**Office Action Summary**

10/781,253

This is the first Office Action for application number 10/781,253 Quick-Adjusting Mounting Head, filed on 2/18/04. Claims 1-20 are pending.

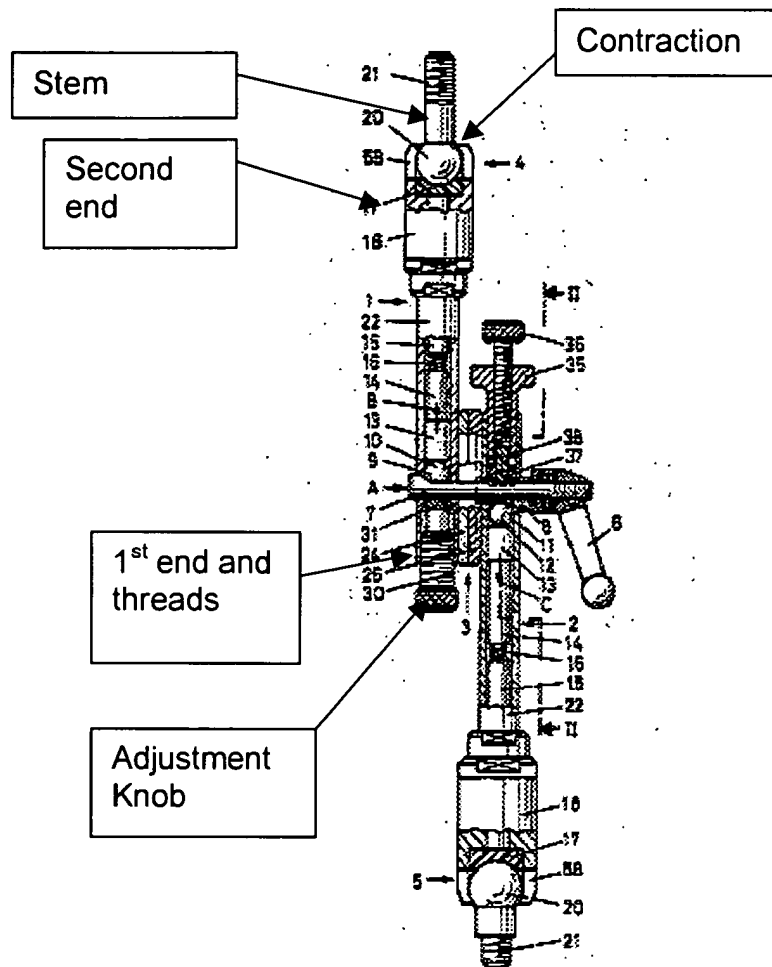
Claims 1-3 and 5-8 are rejected under 35 U.S.C. 102(b) as being anticipated by United States Patent No. 4431329 to Baitella.

The patent to Baitella discloses a mounting head allowing a user to adjustably mount an object to a rod, having a cylindrical body (1, 4), including a hollow interior, a first end, a second end, a long axis, a rod opening (near 7) passing completely through the cylindrical body in a direction which is approximately transverse to the long axis;

a threaded receiver proximate the first end, a contraction (See Drawing Below) proximate the second end, an opening proximate the second end, a ball (20), located within the hollow interior of the cylinder, proximate the contraction wherein the ball has a stem (See Drawing Below) extending out the opening, a ball clamp (13, 14, 15, 17) located within the hollow interior of the cylinder, proximate the contraction, an object mounting means (threaded portion of 21) attached to the stem for mounting the object to the stem, and an adjustment knob (See Drawing Below), having a threaded portion (30) sized to engage the threaded receiver in the cylindrical body, so that if the user places the rod through the rod opening and between the ball clamp and the threaded portion, and then threads the threaded portion of the adjustment knob into the threaded receiver, the contraction will be drawn against the ball, thereby locking the ball in place, and the rod will be clamped between the ball clamp and the threaded portion thereby clamping the mounting head to the rod. Baitella also discloses a bar clamp (31) in the hollow interior of the cylinder between the ball clamp and the threaded portion of the adjustment knob, so that if the user places the rod through the rod opening and between the ball clamp and the bar clamp, and then threads the threaded portion of the adjustment knob into the threaded receiver, the contraction to be drawn against the ball, thereby locking the ball in place, and the rod will be clamped between the ball clamp and the bar clamp, thereby clamping the mounting head to the rod. Baitella also shows a washer (24) located between the bar clamp and the threaded portion of the adjustment knob and the ball clamp (13, 14, 15, 17) has a first end that opens into a ball receiver shaped to receive a ball and a second end which opens into a rod receiver

shape to receive a rod and the bar clamp (31) has a first and a second end, the first end of the bar clamp (31) opens into a rod receiver shaped to receive a rod, wherein the ball clamp and the bar clamp includes a flat on the end.
